DRAINAGE REPORT

**TUYET SON BUDDHIST CENTER  
LOT 2 BLOCK 5 HENDREN SUBDIVISION  
12125 CENTRAL NE  
Albuquerque, New Mexico**

**From:** [Rael, Rudy E.](#)  
**To:** ["David Soule \(david@riograndeengineering.com\)"](#)  
**Cc:** [Carrillo, Abiel X.](#)  
**Subject:** Tuyet Son Buddhist Center  
**Date:** Tuesday, September 20, 2016 2:33:00 PM

Based upon the information provided in your resubmittal received 4/29/16, the above referenced Grading and Drainage Report and plan cannot be approved for Preliminary Plat, Grading Permit or Building Permit until the following comments are addressed:

<b>LOT 5-1, BLK 5 HENDREN ADDITION</b> TYPICAL NEIGHBORHOOD MAP <b>GRADING AND DRAINAGE PLAN</b>	<b>DATE</b> 8-2-18 <b>SHEET #</b> 1 OF 1

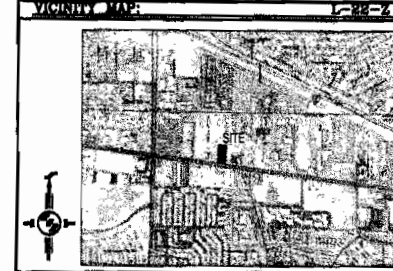
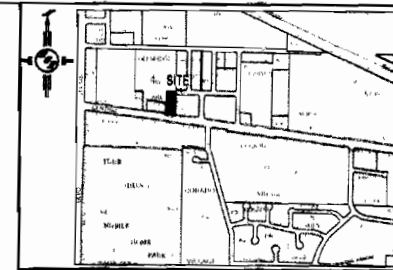
- Provide a detail for the compacted Berm. Will it be protected from erosion?
- At the northern end of the property there is a box with a door, is this a future building or a pond?
- Are the ponds sized for the future buildings?
- Are the dark lines between the existing pavement and new pavement curbing?
- What is the double box at elevation point 53.00?
- Provide a water block at the entrance of this site.
- Increase the font on the flow points in Central Ave.
- At the front of the new building, is the dotted line a swale as called out in the center of the property?  
If so, how will flows pass the sidewalk from east to west. Provide a detail or a note.
